NO.	DATE	BY	REVISIONS
1	03/27/06	inh	revised ground floor use
2	04/18/06	inh	revised per planning dept. comments

Steelhaus
(formerly Firth & Fulton)
Site Plan Amendment
(Rezoning Petition # 2003-095)
1600 Fulton Ave., Charlotte, NC

DATE: April 24, 2006
TO: Gary Huss, Zoning Coordinator
FROM: Debra Campbell, Planning Director
SUBJECT: Administrative Approval for Petition No. 2003-95 by Monte Ritchey.

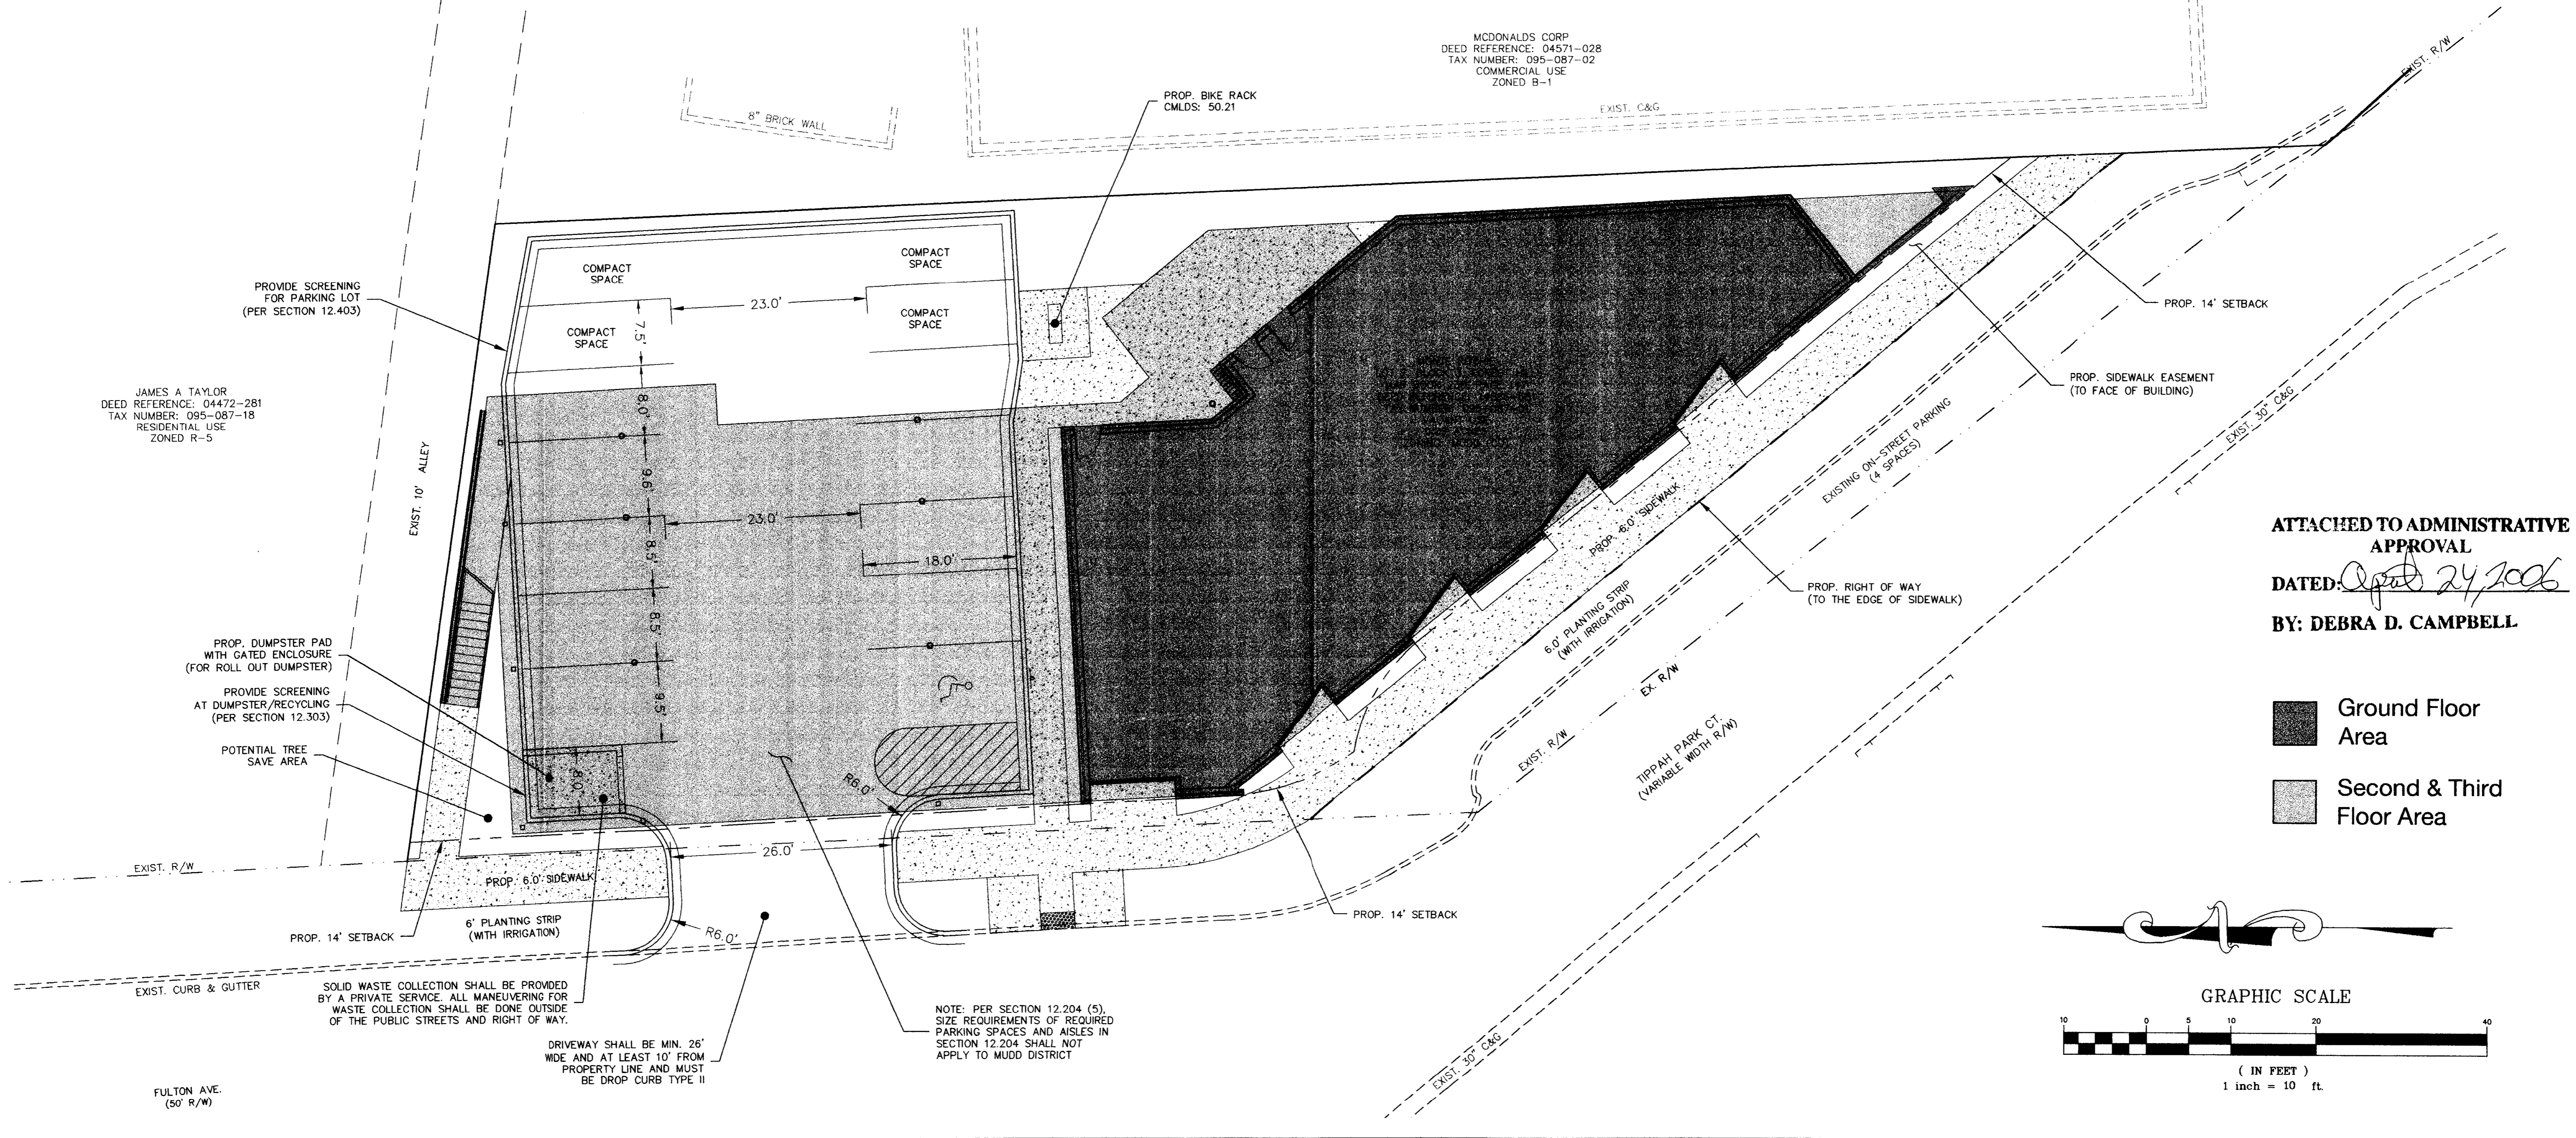
Attached is a revised plan for the above petition. The plan has been revised to convert back to the originally approved 12 residential units, reduce the office and retail square footage to 3,600 and reduce the planting strip width to 6 feet. Since these changes are minor, I am administratively approving this revised plan. The changes are minor since they reduce the allowable square footage. Please use this revised plan when evaluating requests for building permits and certificates of occupancy.
Note that all other ordinance requirements still apply.
